菲比國際項目顧問有限公司
FiBi International Project Consultancy Co. Limited

編號：FBI-LTTY498-RD2025-0801-01

有關A/LTTY/498規劃申請回覆意見：

消防裝置布局圖

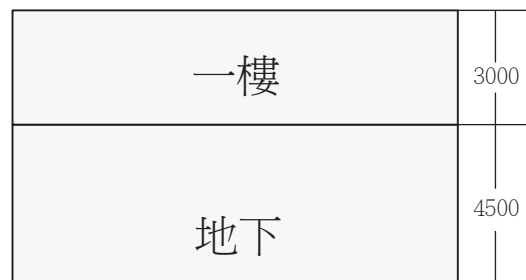
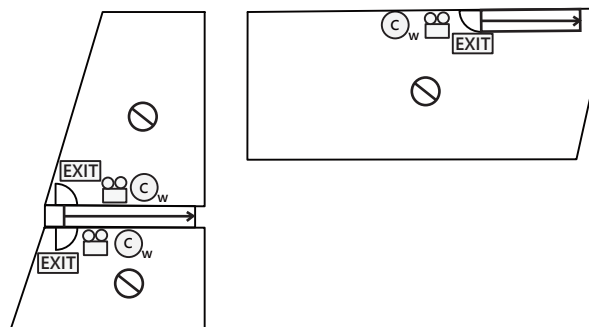
With regard to the submitted FSI proposal in your preceding email, I have the following comments:

- i. For enclosed structure with gross floor area not exceeding 230m², only fire extinguisher and Stand-alone Fire Detector shall be provided;
- ii. In relation to i. above, where two or more Stand-alone Fire Detectors are installed in an enclosed structure, all stand-alone detectors shall be interconnected (either wired or wirelessly) such that when one of the stand-alone fire detector is triggered, all connected Stand-alone Fire Detectors shall sound an alarm simultaneously;
- iii. The Stand-alone Fire Detector shall be provided in accordance with the "Stand-alone Fire Detector General Guidelines on Purchase, Installation & Maintenance [Sep 2021]"; and
- iv. Emergency lighting, directional and exit signs are considered as self-upgrade and not a mandatory requirement by this Department.

2. 附上更改的消防裝置布局圖。

煤氣
Towngas

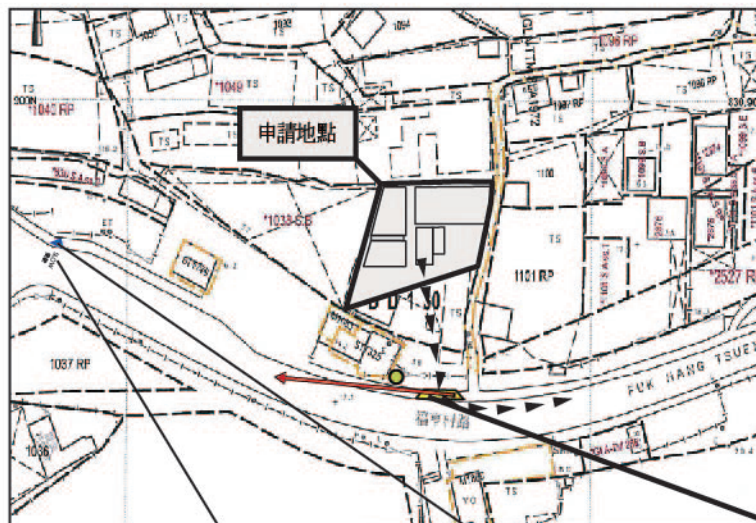
1. Please note that there is a high pressure underground town gas transmission pipeline in the vicinity of the proposed temporary shop and ancillary office. In this connection, grateful if you could provide an estimation of aggregated working population induced from the captioned proposal for our consideration. Your attention is drawn that Quantitative Risk Assessment would be required from the project proponent/consultant to assess the risks posed by the gas installation and hence to identify any mitigation measures to lower the risk levels, if the proposal will result in a significant increase in population.

2. The applicant/consultant/works contractor shall liaise with the Hong Kong and China Gas Company Limited in respect of the exact locations of existing and planned gas pipes/gas installations in the vicinity of the application site and any required minimum set back distance away from them during the design and construction stages of the temporary shop and ancillary office.

1. 場地工作人口約每天4人。
2. 已向香港中華煤氣有限公司聯繫及拿煤氣裝置的確實位置圖(P.6)。
3. 明白。

車輛進出口通道竣工圖

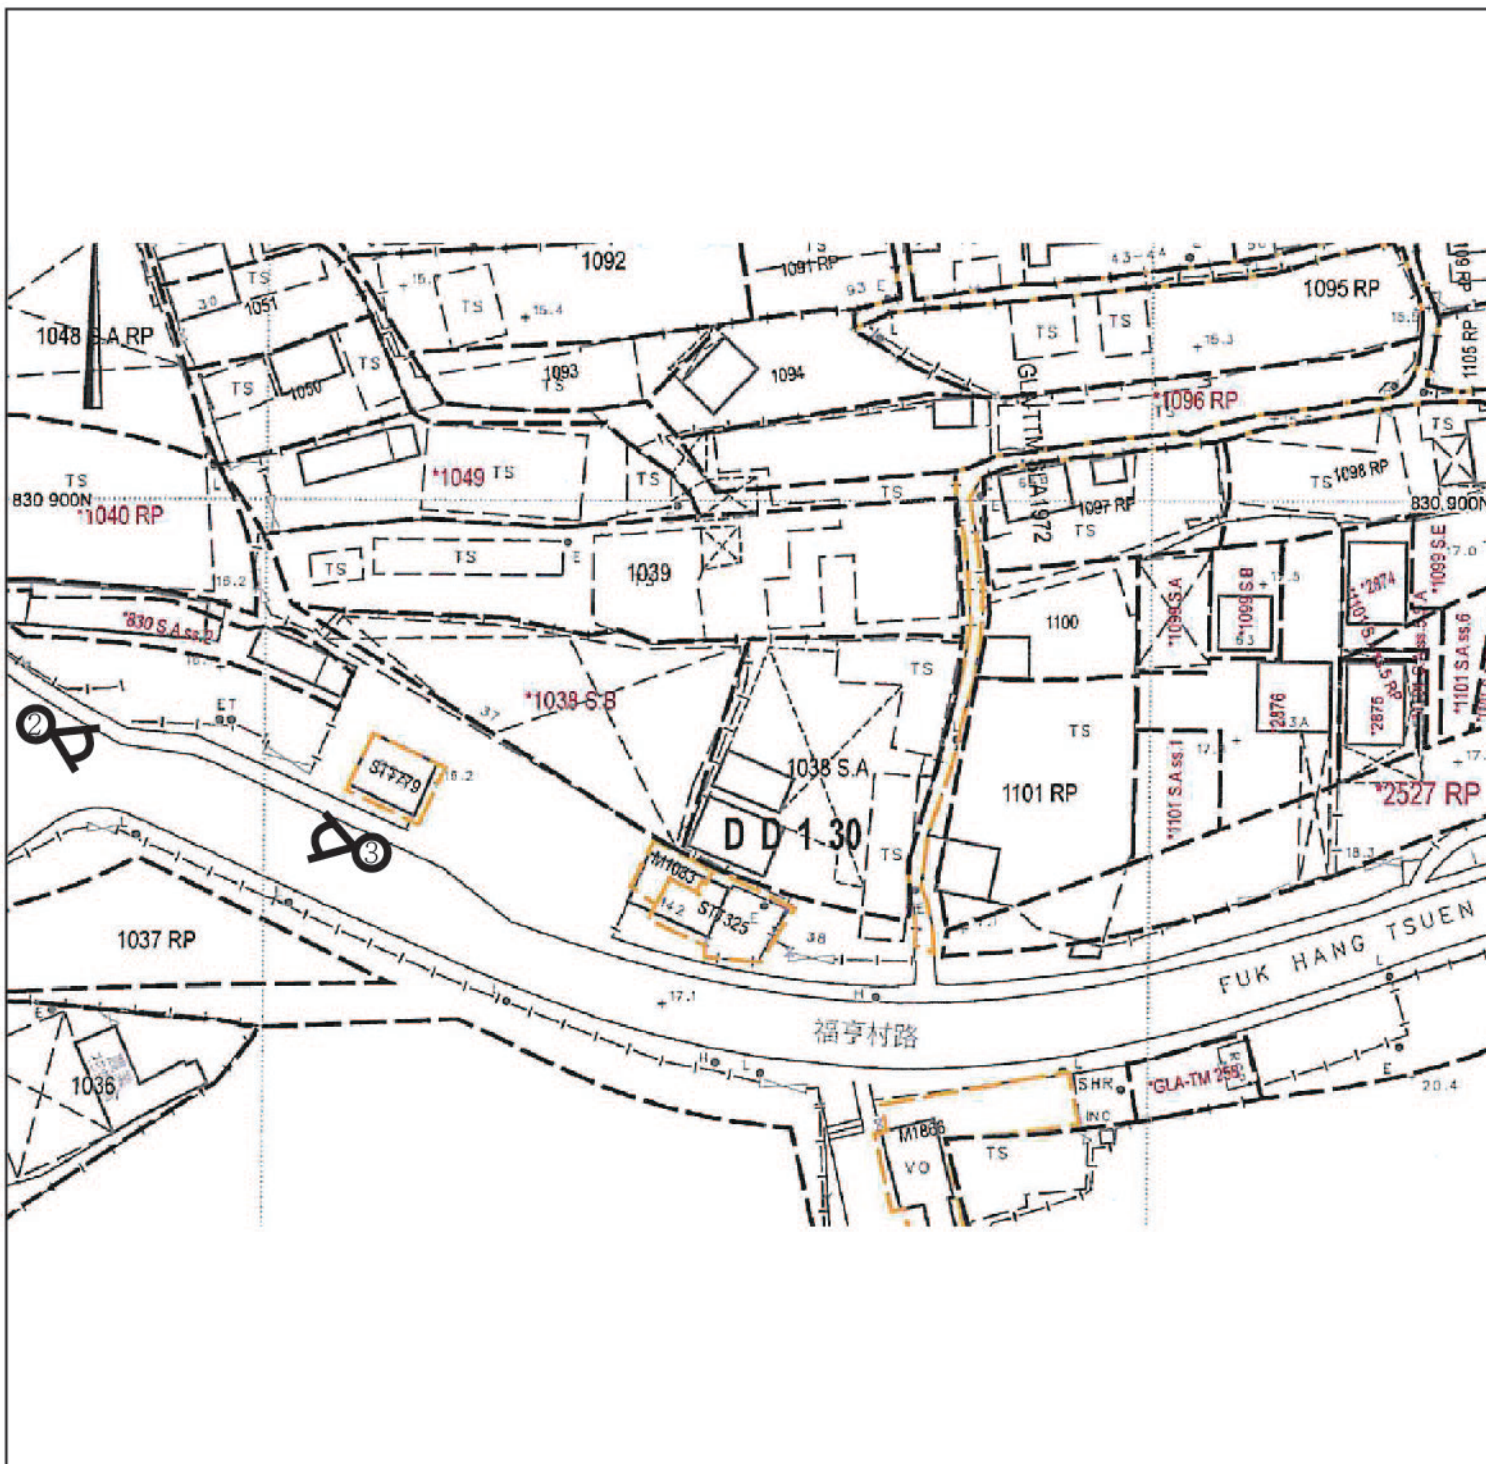
- a. As HyD observed non-conformance of the vehicular run-in/out constructed under the last planning application No. A/TM-LTTY/461, the applicant is required to rectify the defects to the satisfaction of HyD for compliance of approval condition (b) (i.e. implementation of a run-in/out proposal).

- d. It is noted that a manoeuvring space is reserved within the proposed site. Please ensure that no queuing and / or waiting of motor vehicles from the subject site onto public roads would occur and no motor vehicles shall be permitted to reverse into and out of the subject site onto adjacent public roads.

- a. 明白見P.7-13圖。
- b. 明白。
- c. 申請人會徵詢相關部門和當地持份者的意見。
- d. 機動車輛不會在公共道路上排隊等候,亦不會倒車駛入
或駛出擬建工地進入相鄰的公共道路。

1. 車輛出口建設於最東面，車輛駛出時將會向東面駛出。
2. 車輛出口位置至可見位置約85呎，有足夠距離看到駛來車輛。
3. 距離申請位置約50米安裝交通標誌位置(TS410)
4. 在道路上標誌SLOW慢駛(RM1141)
